# Access Compliance Report

## Public Rights-of-Way

### (Curb Ramps)

Intersection ID: 11074	Main Street: WESLEY HEIGHTS_WY	Cross Street: GRANDIN_RD	Location: W
ADA ID: CDA271727B0B	Ramp Type: PerpDiag	Initial Pass/Fail: Fail	Overall Compliance: No
			Severity Score: 21.25

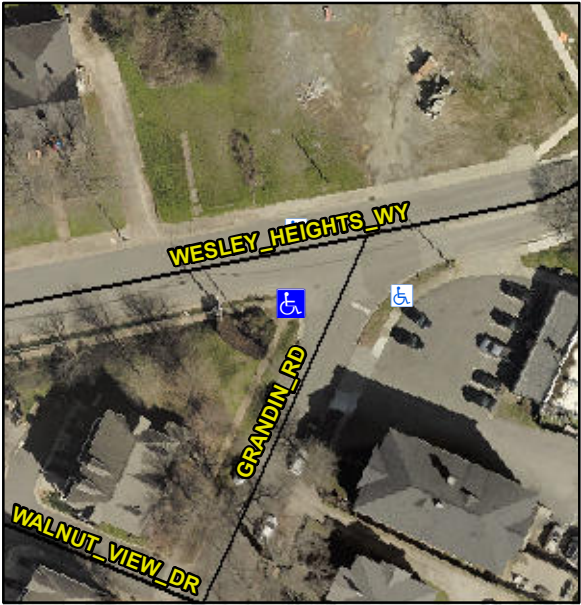
Codes/Mitigation Info/Possible Solution		Field Measurements/Component Compliance			
	Possible Solutions:				
	<b>Remove &amp; Replace Curb Ramp With Two New Directional Ramps or Equivalent.</b>				
	Surveyor Notes:				
	<b>N/A</b>				
	PROW/ADA:				
	<b>Not Found, R304.5.1, R304.2.2</b>				
	Street 1 Name	GRANDIN RD			
	Stop Condition-Street 2	StopSign			
	Street 2 Name	WESLEY HEIGHTS WY			
	Stop Condition-Street 1	None			
	Total Cost:	\$ 3200.00			
Compliance	Description	Data	Compliance	Description	Data
N/A	Ramp Length (in)	117.5	No	Ramp Slope (%)	8.9
No	Ramp Width (in)	46.5	Yes	Ramp XSlope (%)	1.7
N/A	Flare Type LT	N/A	N/A	Flare Type RT	N/A
N/A	Flare Slope LT (%)	N/A	N/A	Flare Slope RT (%)	N/A
N/A	Flare Traversable LT?	N/A	N/A	Flare Traversable RT?	N/A
N/A	Landing Length (in)	N/A	N/A	DWS Provided?	N/A
N/A	Landing Width (in)	N/A	N/A	DWS Contrast?	N/A
N/A	Landing Slope (%)	N/A	N/A	DWS Length (in)	N/A
N/A	Landing X Slope (%)	N/A	N/A	DWS Full Width?	N/A
